RE: Capital Paving Inc. – Proposed Montrose Pit
Part lots 71, 74 & 75, Concession GCT
Township of Woolwich, Region of Waterloo
Montrose Pit – Noise Peer Review Response

RE: Montrose Pit Noise Study – Peer Review

I have reviewed the peer review correspondence of January 18, 2010 from Mr. John Emeljanow, P.Eng. of Valcoustics Canada Ltd. to Mr. Jeremy Vink of the Township of Woolwich. Our responses to the issues raised by Mr. Emeljanow are as follows:

Acoustical Berming - Receptor R1

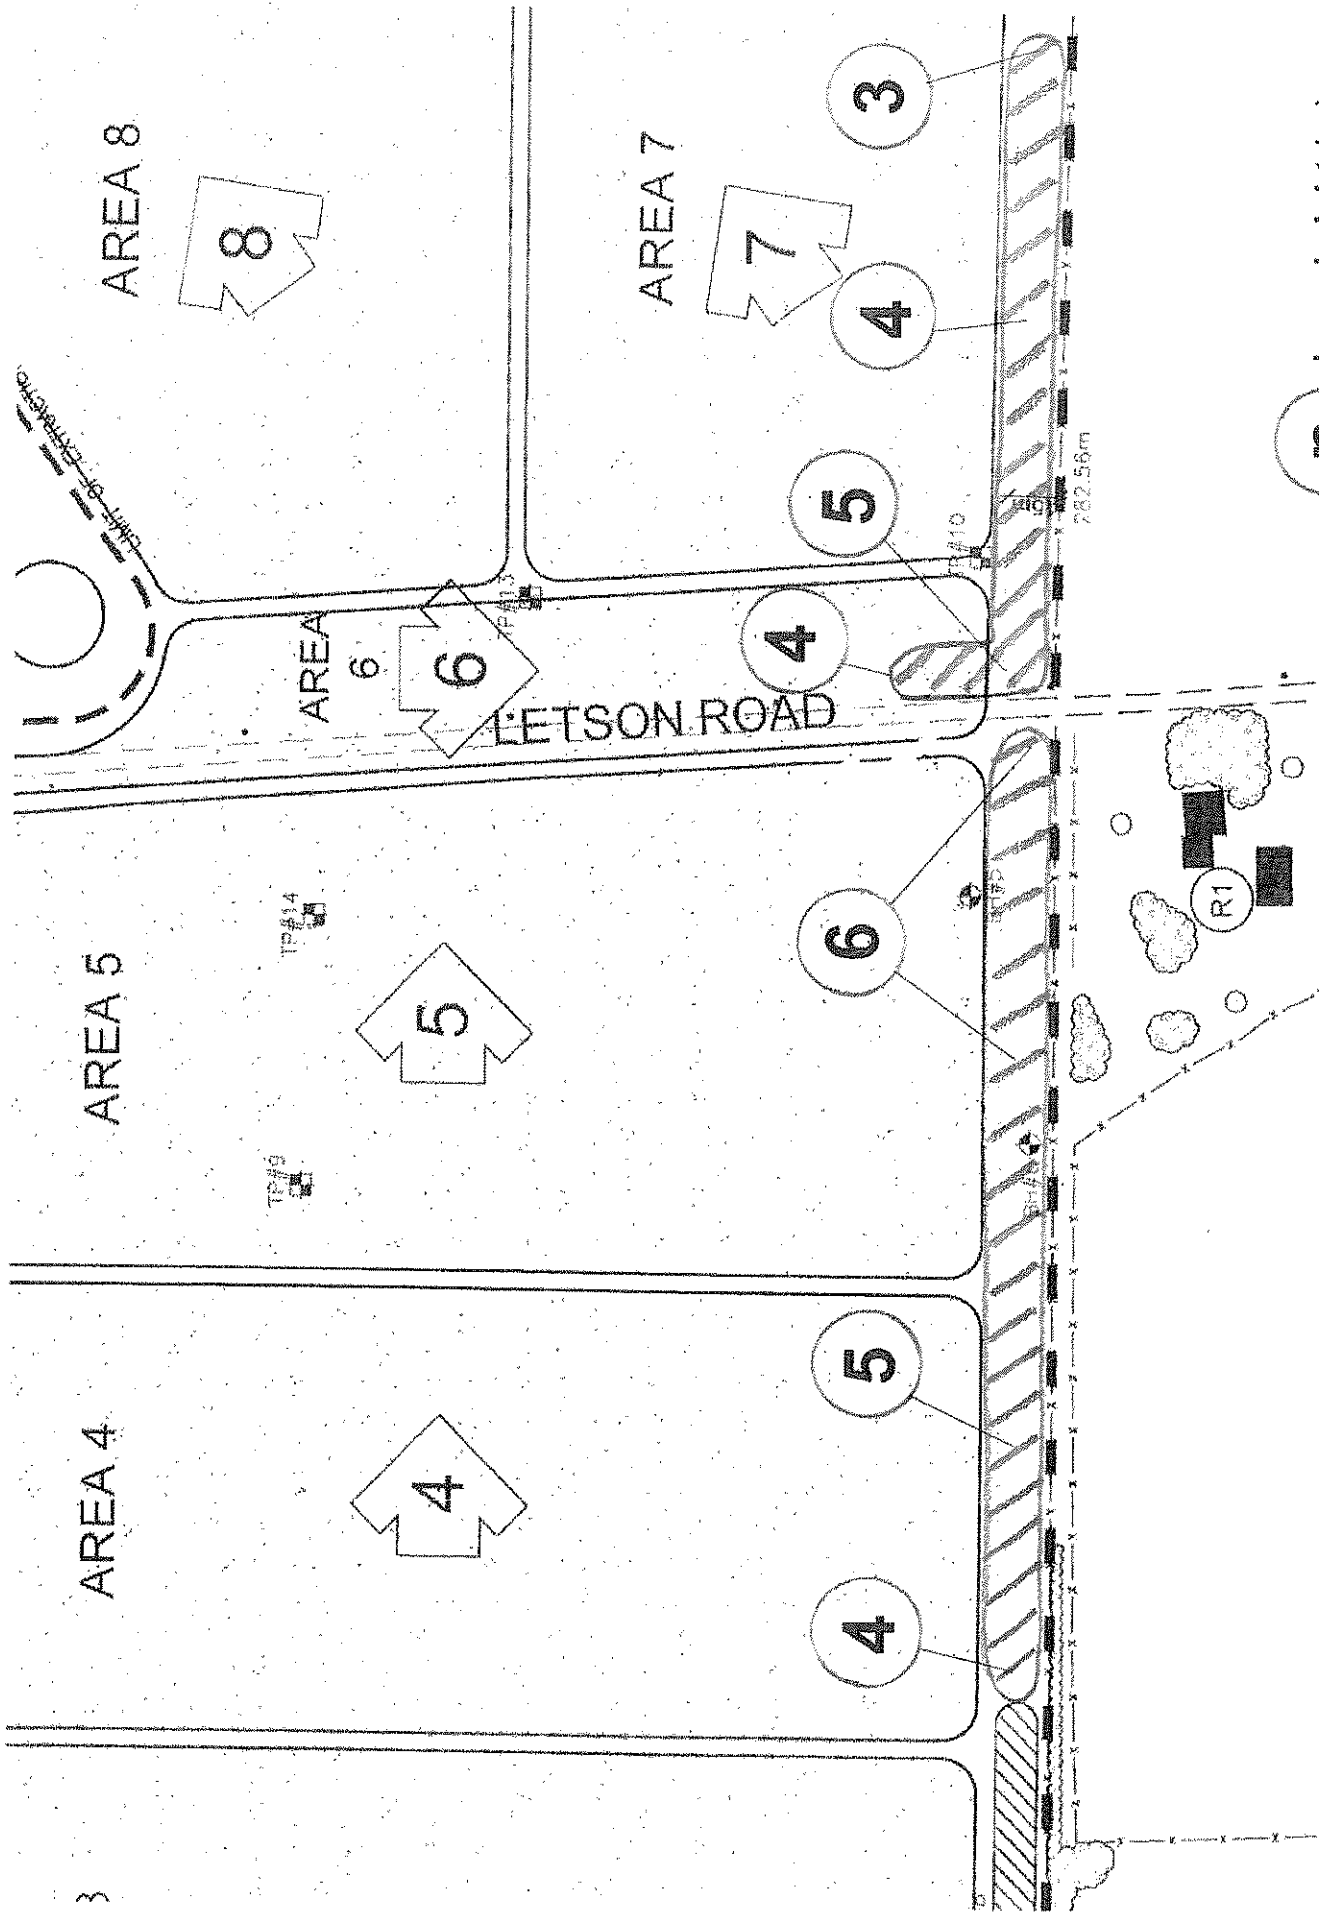
1. Berming along the south perimeter is required as indicated on the attached figure. The new berm segment west of Letson Drive shall be constructed prior to processing on site. Construction of the berm east of Letson Drive shall be phased to ensure that the Area 6-8 extraction operations are shielded when located within 250 metres of residence R1.
